Newsletter

08.2019

DIN40 Eyelet

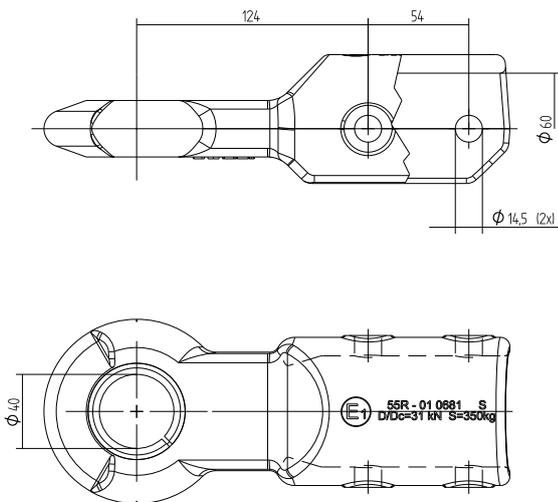
Below we present the modernization of the eyelet DIN40 - 98762093, whose casting has been modified so that it is possible to assemble in the same way as the couplings, that is, by applying it on the slide.

The designation according to EG has already been omitted on the occasion of structural changes, therefore we would like to point out that this should be verified with the entries in full truck approvals

Old one

New one
